Environmental Review Team Report

Oak Ridge Estates  
Andover, Connecticut

January 1979

OAK RIDGE ESTATES, SECTION II  
ANDOVER, CONNECTICUT

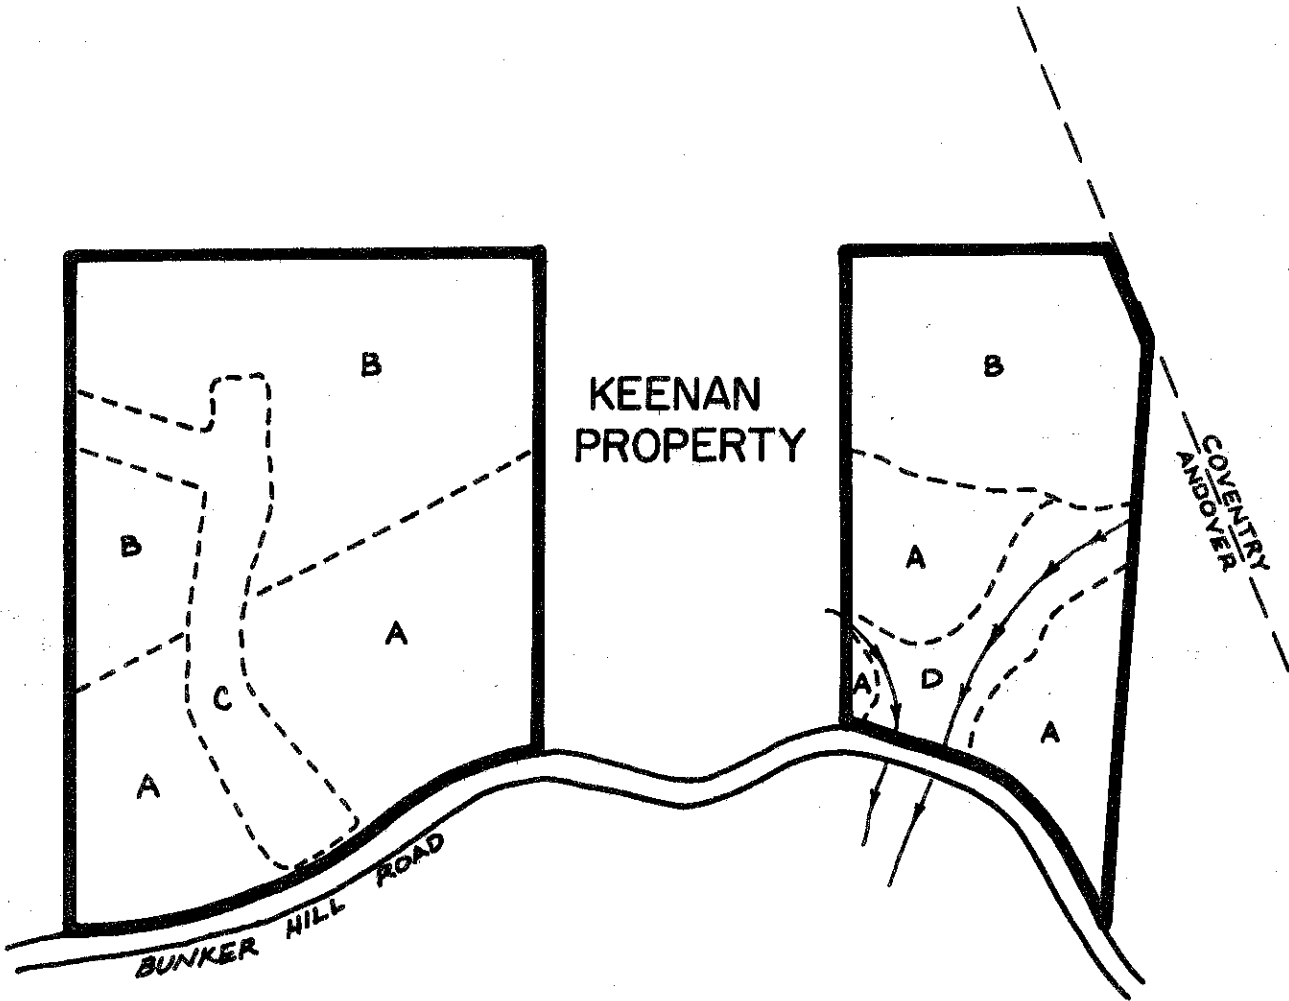
Stand B: (Mixed Hardwoods) This 12 acre area is occupied by several species of hickories, red oak and white oak with occasional sugar maple, white ash, red maple and black birch. The trees are pole sized, crowded and many are unhealthy. Crowding creates a risk of residual tree breakage and blowdown, if corridors are cleared for driveways leaching fields or buildings. All trees here, have a retarded diameter growth and the resulting low vigor reduces the probability that they will be able to survive soil aeration or soil moisture level changes. The understory is made up of spice bush, blue beech and maple leaf viburnum. Christmas ferns dominate the ground cover in addition to several species of club moss.

Stand C: (mixed Hardwoods) This three acre swath was cleared approximately five years ago for a roadway. Seedling sized sprouts from felled maple, oak and hickory trees are growing vigorously where soil has not been severely altered. Spice bush, blue beech and patchy areas of green brier are becoming dense due to the increased sunlight. On the southern tip of this stand, multiflora rose is also becoming dense. Grasses, goldenrod, sweet fern and staghorn sumac have become established on approximately 1/3 acre where topsoil has been removed.

Stand D: (Mixed Hardwoods) Pole size sugar maple, red oak, black birch, shagbark hickory and red maple are crowded on this two acre site. The understory is dominated by spice bush and viburnum. Ground cover consists of ferns and club moss.

The seasonally high water table and rocky nature of this site caused the development of shallow rooted trees. These trees are growing slowly and have so low vigor that any soil disturbances may result in their death.

Crowded trees on rocky, wet soils which have produced shallow root systems are susceptible to blow down. Development which opens these areas up may create corridors for wind to flow through rather than over a stand which would lead to increased blow down occurrence. Development in these areas should be carefully planned and kept to a minimum where possible.

## SITE DESIGN

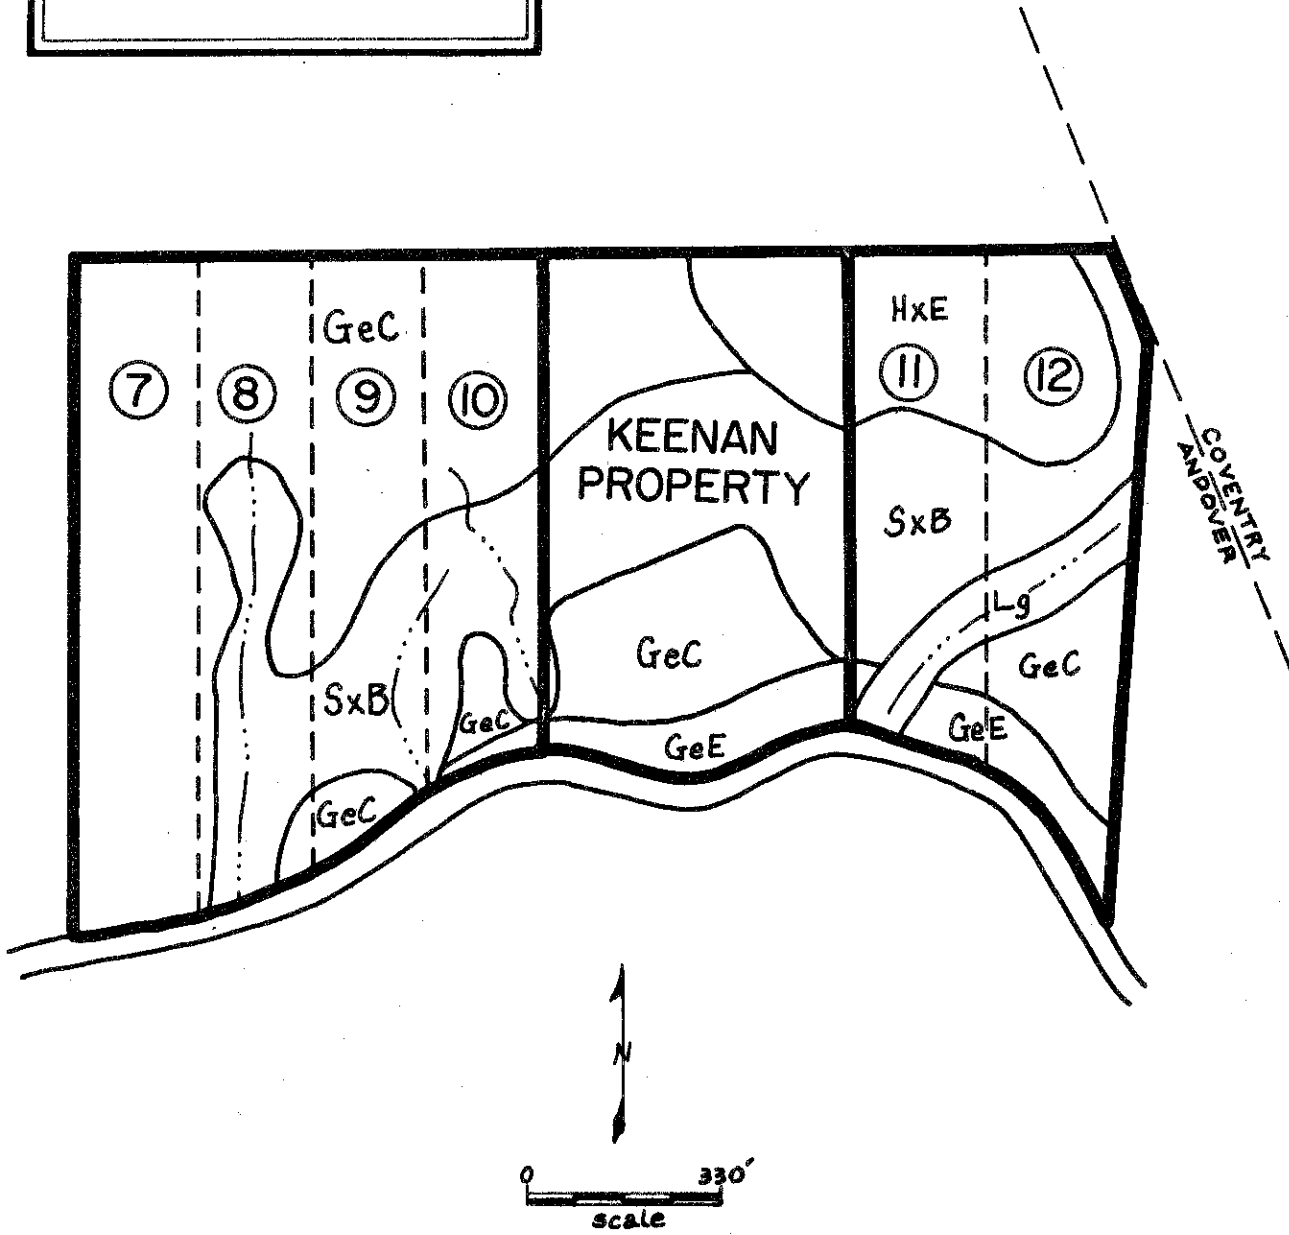
The 28 acre parcel has been divided into six lots ranging in size from three to five acres. Each has approximately 200 feet of frontage on the north side of Bunker Hill Road. As these lots are long and narrow, they all include large areas of steep slope which will impose limitations for establishment of buildings and septic leaching fields. Examination of soils data and observations on the date of the field review indicate that areas which are currently proposed for building (those areas where test pits and perc tests were done) may not be satisfactory during all months of the year due to seasonally high water tables. Unless further testing was done, it would be difficult to assess the current proposal's ability to produce six buildable lots. Building locations and driveway access points should be established on the subdivision plan before final approval is given.

Of major concern are the number of driveways which will be entering this very winding portion of Bunker Hill Road. Field inspection revealed severe line of sight problems with driveways exiting from lots 9, 10, 11, and 12. Although remedial measures were discussed at the field review, they did not appear to be adequate for the existing problem. In order to provide adequate visibility from lots 11 and 12, trees and a stone wall to the south side of Bunker Hill Road in the vicinity of those lots would have to be removed. Alterations to the north side of Bunker Hill Road have been discussed by the developer, but should be staked in the field to assess their adequacy before final approval is given for this subdivision plan.
